COUNCIL REPORT

Date:	September 1, 2023
From:	Hanna Demyk, Planning Technician
Subject:	Proposed Coach House Development Permit for 1160 Sinclair Street
File:	1010-20-22-143

THAT proposed “Development Permit No. 22-143” for 1160 Sinclair Street as outlined in the report dated September 1, 2023, be denied.

Site Plan

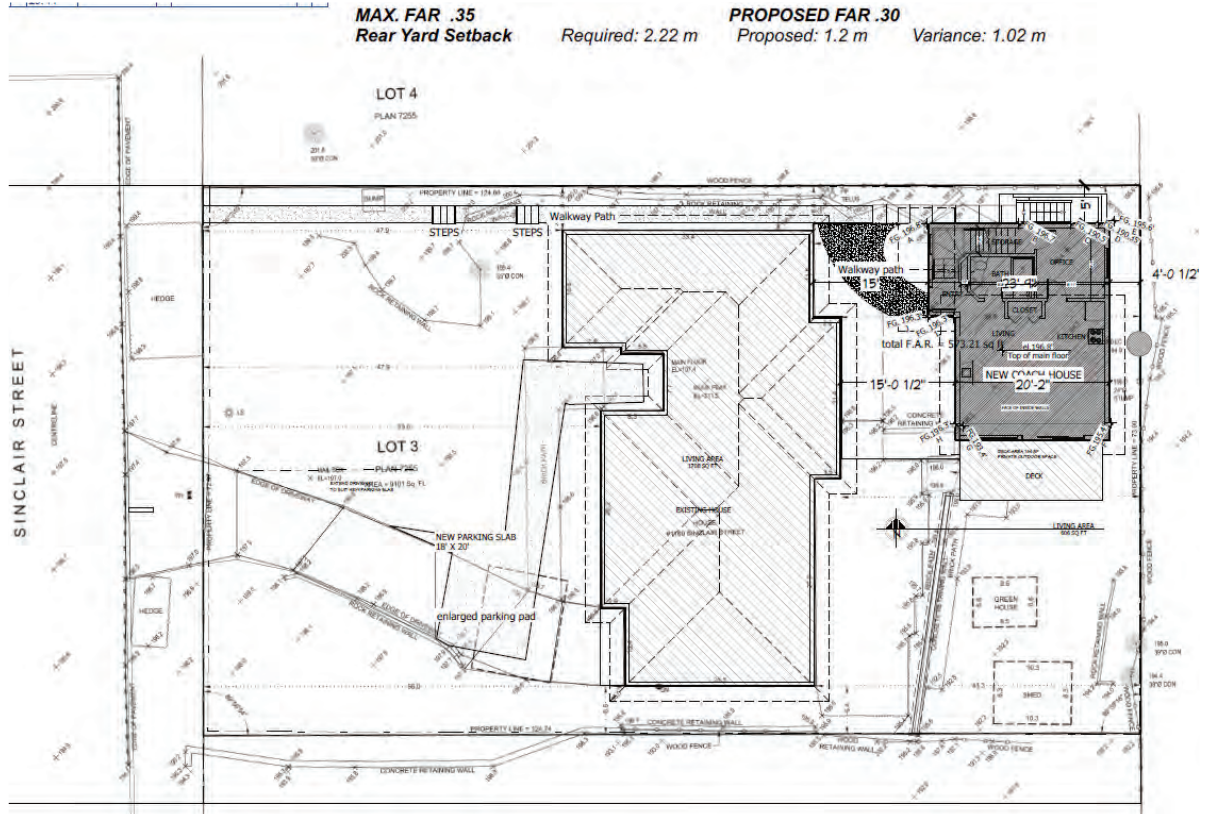
On July 5, 2023, the applicant submitted an itemized response to public feedback (**Appendix D**) and submitted what they stated to be revised plans (**Appendix B**). However, upon staff review it was determined that no revisions to the siting or height of the coach house were proposed, the applicant did not eliminate any zoning variances¹, the pedestrian access was not changed, nor did the applicant provide any additional arborist information as requested.

¹ In the July 5, 2023, submission, the applicant stated that the proposed zoning variance for building separation was eliminated to address public concerns. However, upon review of the plans no changes were made to the siting or design of the coach house and the applicant incorrectly measured the building separation distance.
